COMMONWEALTH OF PENNSYLVANIA
PENNSYLVANIA GAME COMMISSION

ADDENDUM NO. 1

PROJECT: PGC-HN-24-01

DESCRIPTION: **PGC – Howard Nursery-
New Forestry Headquarters Building**

Rock Construction Entrance Key Plan

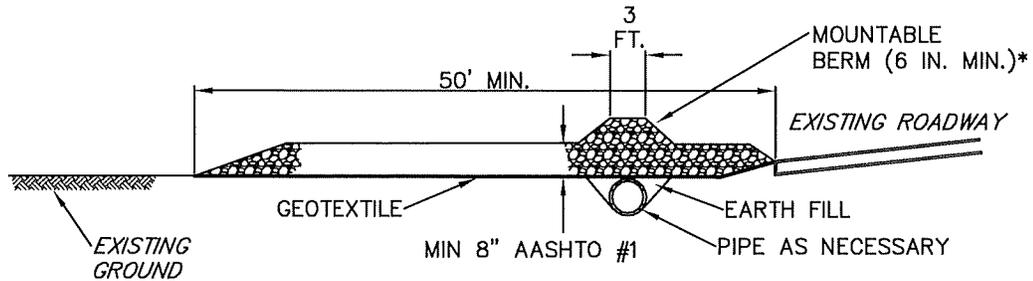
1. See attached Sketch (Rock Construction Entrance Key Plan) and (Rock Construction Entrance Standard Detail #3-1) in regards to the installation of a Rock Construction Entrance. General Contractor to provide appropriate signage indicating "Construction Entrance". Upon completion of project, Construction Entrance to be removed and have all existing conditions restored.
